# **Tweed Heads Travel Lift Boat Facility**

Addendum Review of Environmental Factors

Transport for NSW

Transport for NSW | August 2022

**Figure 1-5: Location of possible dewatering activities**

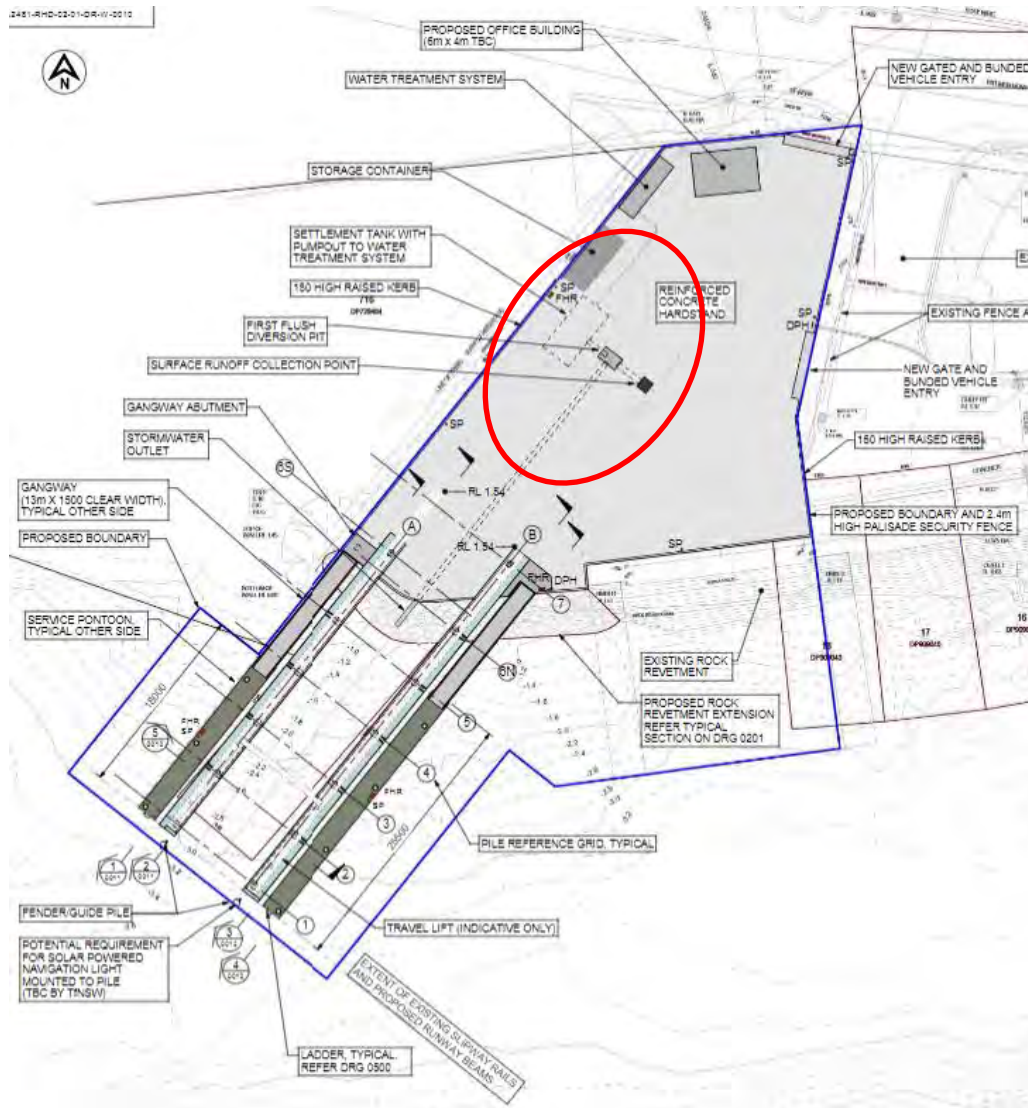
Dewatering was not expected to be required for the construction activities and the Contractor has advised TfNSW that the construction methodology aims to alleviate the need for dewatering activities during the installation of the wastewater storage tank, associated wastewater junction pit and drainage infrastructure. However, after reviewing the mean high-water level data, the Contractor considers that some of the excavation areas may be underwater during stages of the works (particularly high tide events). Therefore, excavation areas that experience groundwater and/or surface water ingress may require dewatering to assist with the contractor's construction requirements. If dewatering is required, a Dewatering Management Plan (DMP) would be prepared.

Figure 3-3: Design details of proposed geotextile fabric marker layer and geogrid

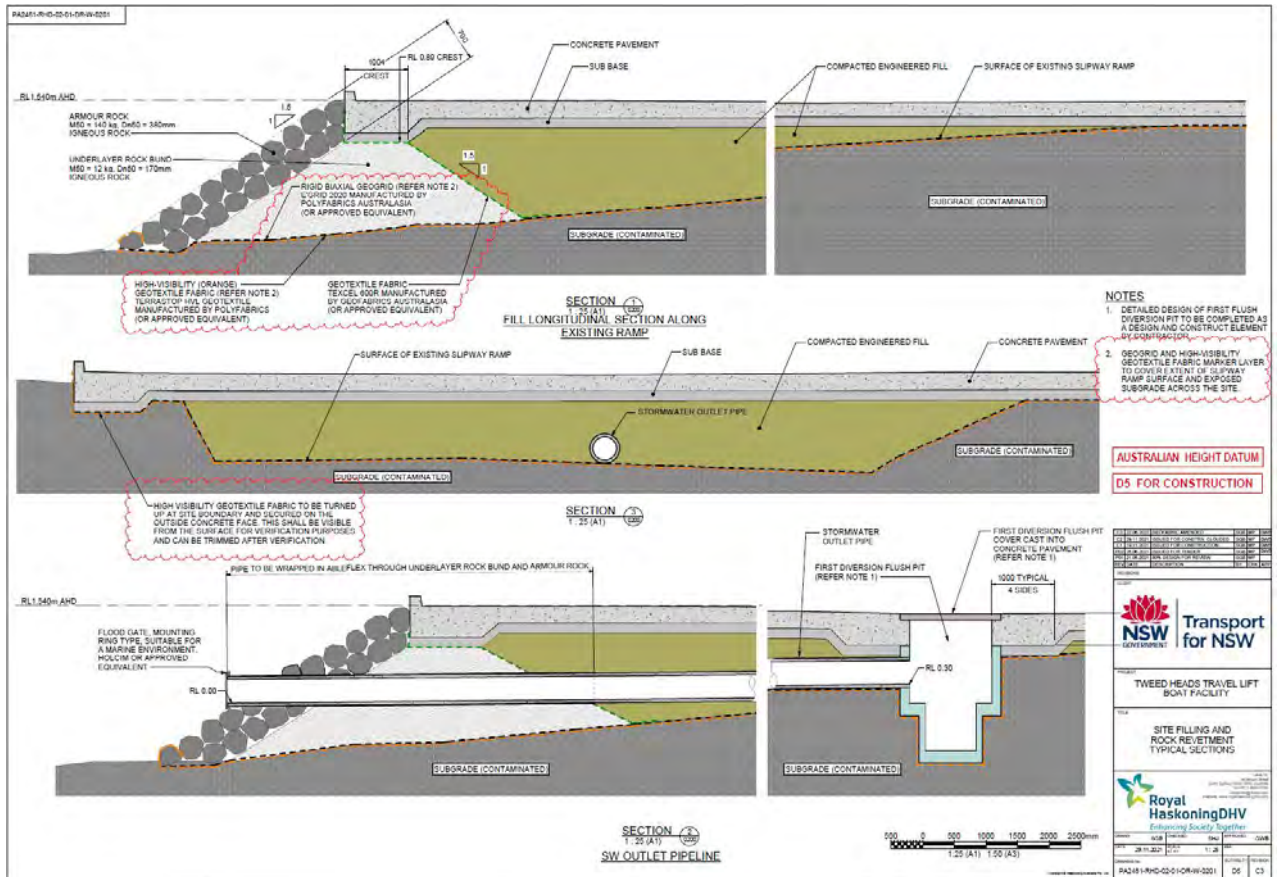
Figure 1-3 shows the extent of the remediation works. Figure 3-3 shows details of the proposed geotextile fabric marker layer and geogrid. All other aspects of the proposed site construction works remain the same.

Remediation is primarily based around the installation of an appropriate capping system over the contaminated soil in remediation Area A (refer Figure 1-3). The existing pavements in minor areas of the site (Areas B, C and D) are not proposed to be disturbed. The capping specified for Area A in the RAP includes high-visibility (orange) geofabric visual marker layer (TerraStopHVL Geotextile, Manufactured by Polyfabrics Australasia or approved equivalent) placed over the contaminated soil ground surface, followed by a geogrid mechanical barrier (E'GRID 2020 Rigid Biaxel Geogrid, Manufactured by Polyfabrics Australasia or approved equivalent) placed directly over the geofabric, followed by engineered fill to achieve site design levels, followed by a subbase and concrete pavement/hardstand as per the construction activities outlined in the project REF.

Title: **SCHEMATIC CROSS SECTION OF AREA A CAPPING - TYPICAL SERVICES INSTALLATION**

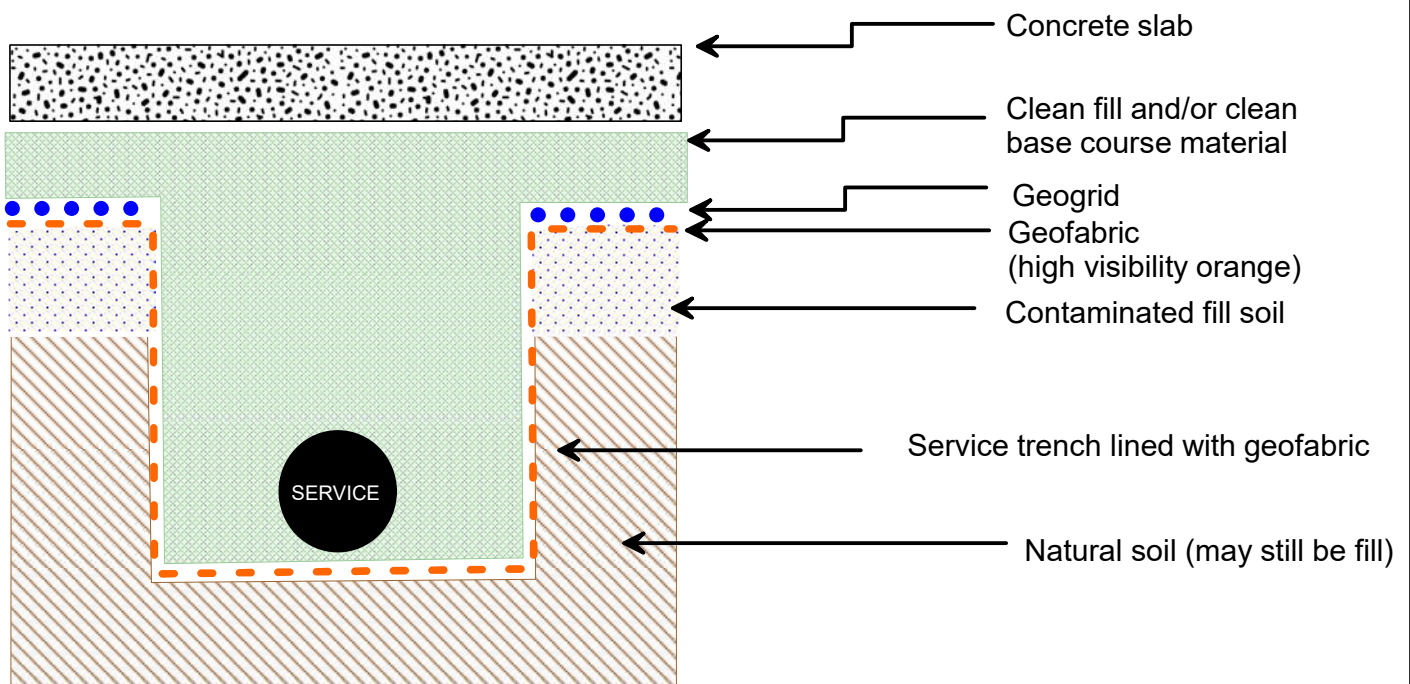
The capping specifications are outlined in the following table and conceptual cross-sections included proposed development plans attached in Appendix B. An additional example of conceptual cross-section for underground services is provided on Figure 3 attached in the appendices. In the event that the capping specification is to be altered following the initial consultation, this must be documented by JKE in Remediation Works Plan (RWP) and reviewed by the site auditor.
